September 30, 2009

**Re: Onate Elementary School Grading and Drainage Plan**  
**Engineer's Stamp date 9-25-09 (H22/D035)**

CS-101

## A1 OVERALL DRAINAGE IMPROVEMENTS PLAN (FOR INFORMATION ONLY)

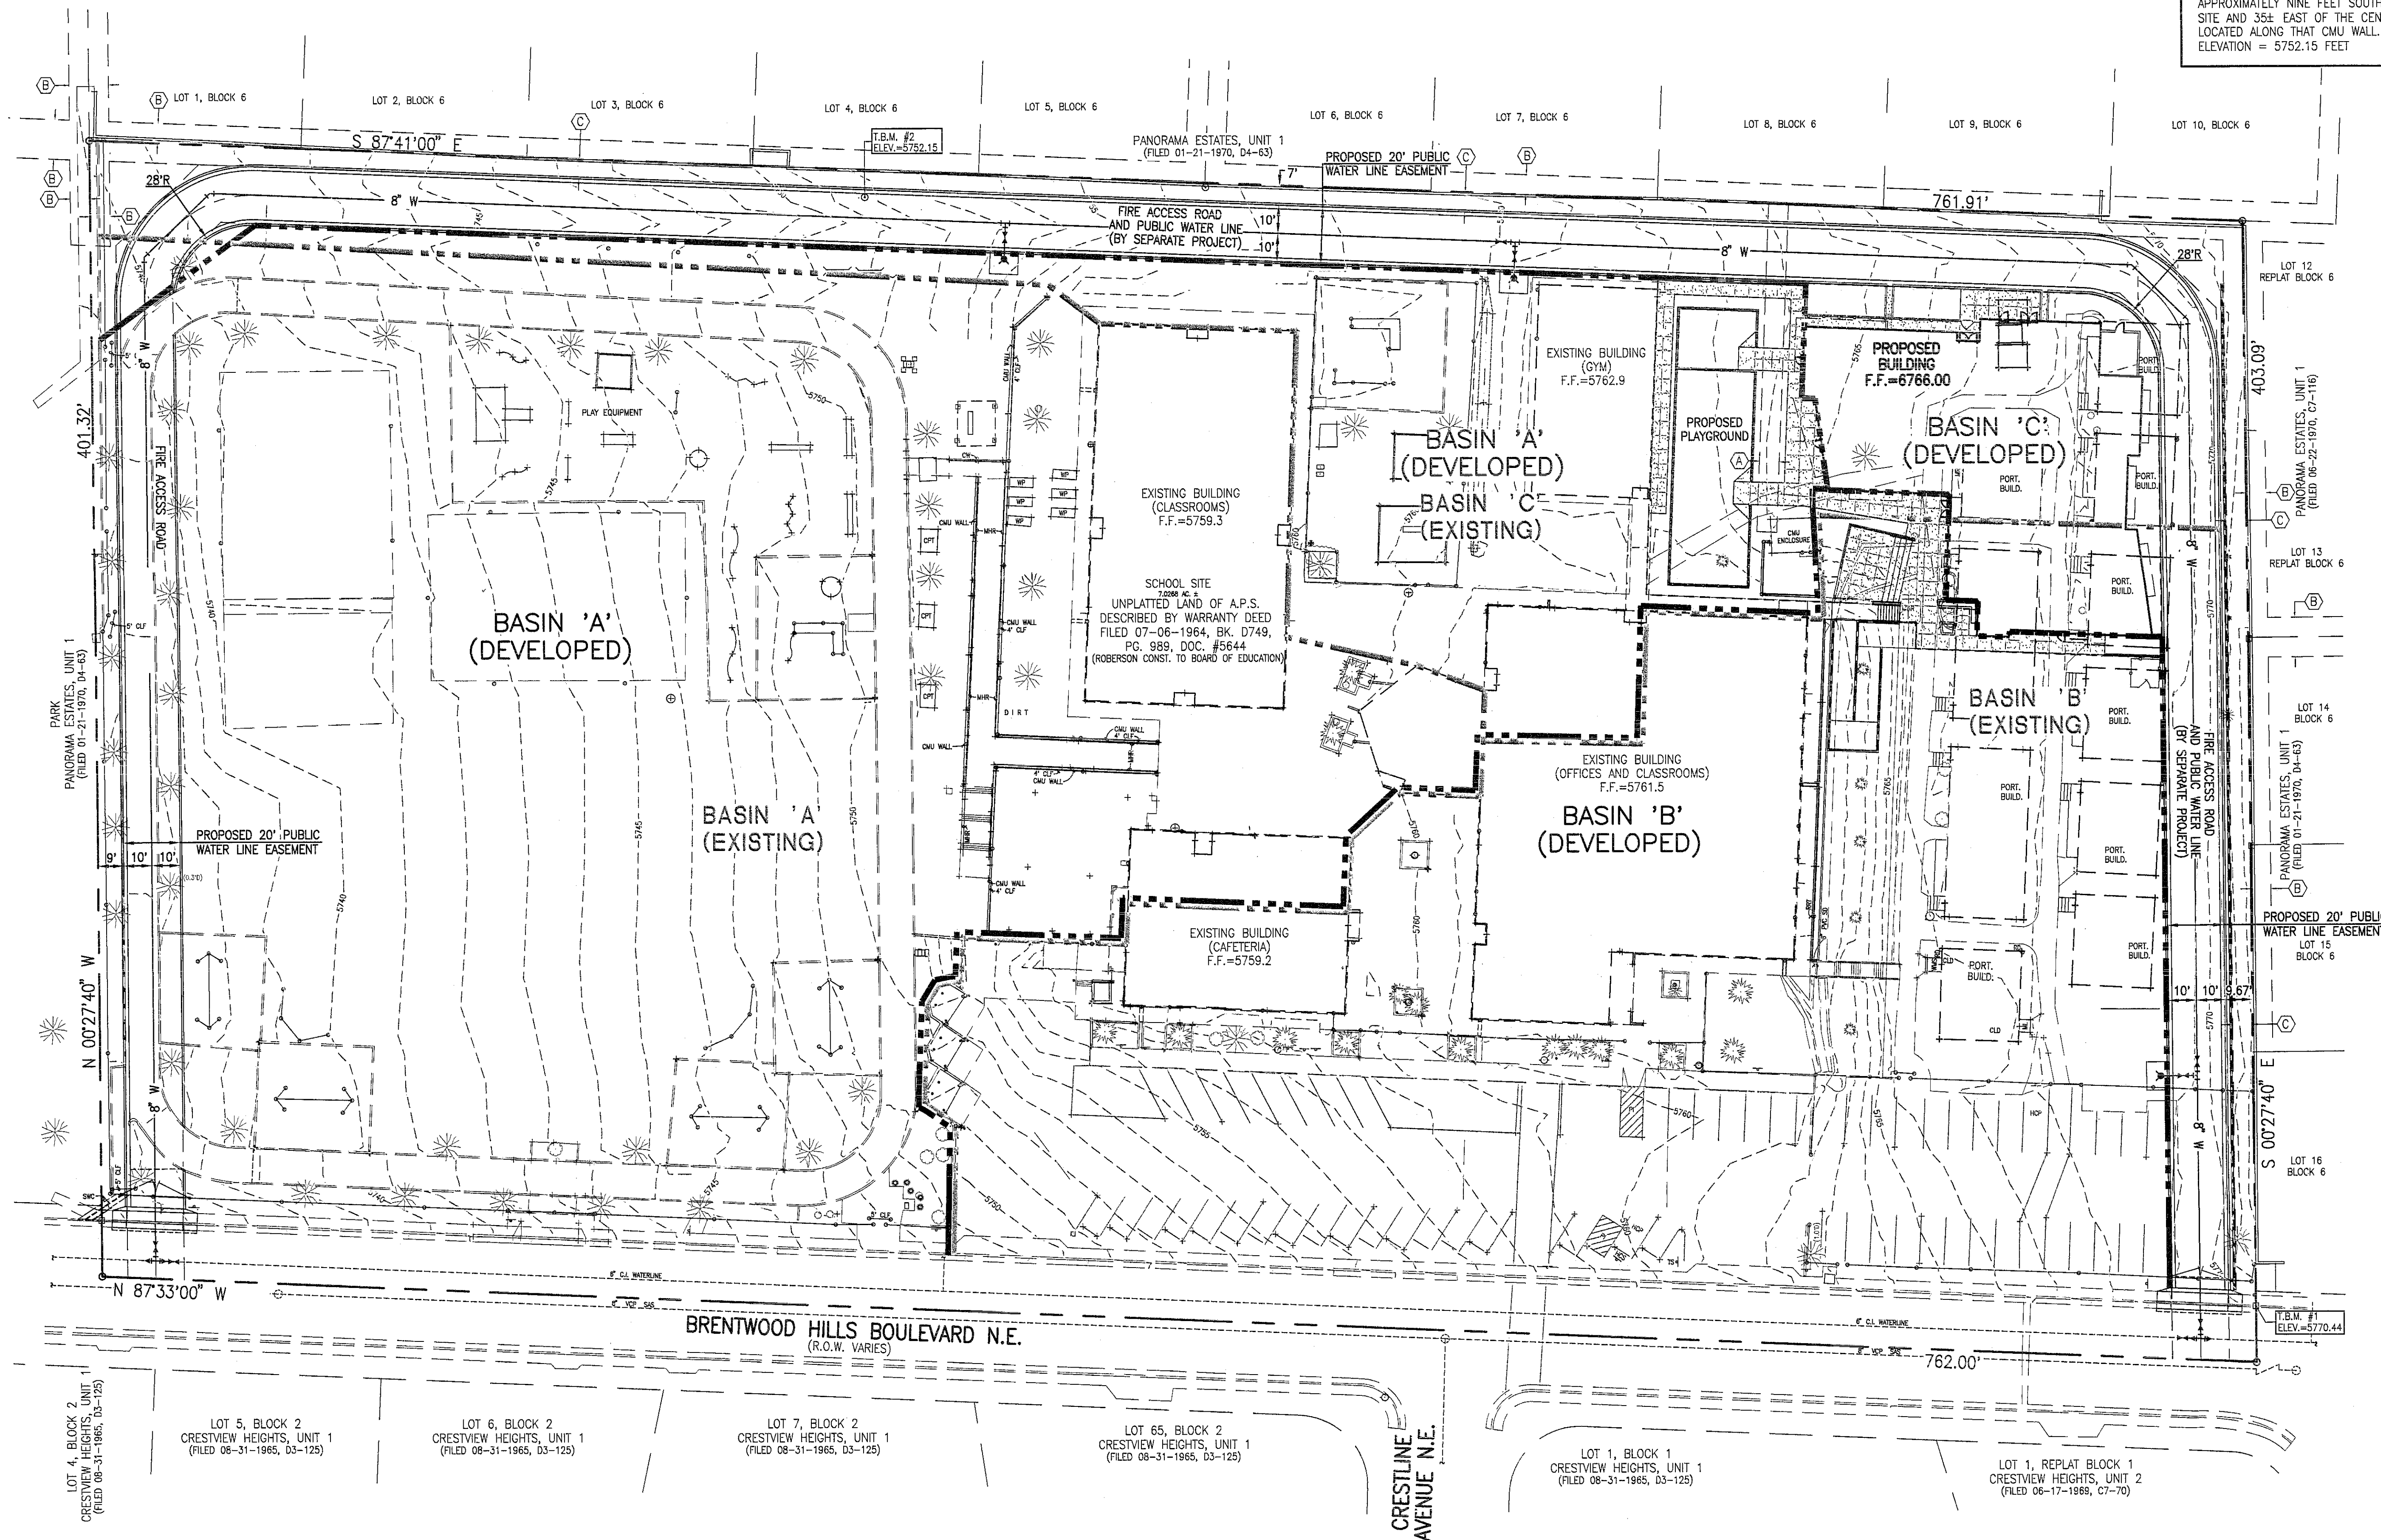
- Engineer Certification per the DPM checklist will be required.
- The fire lane road and the concrete rundown east of the existing Admin and classroom building are required to be built and certified.
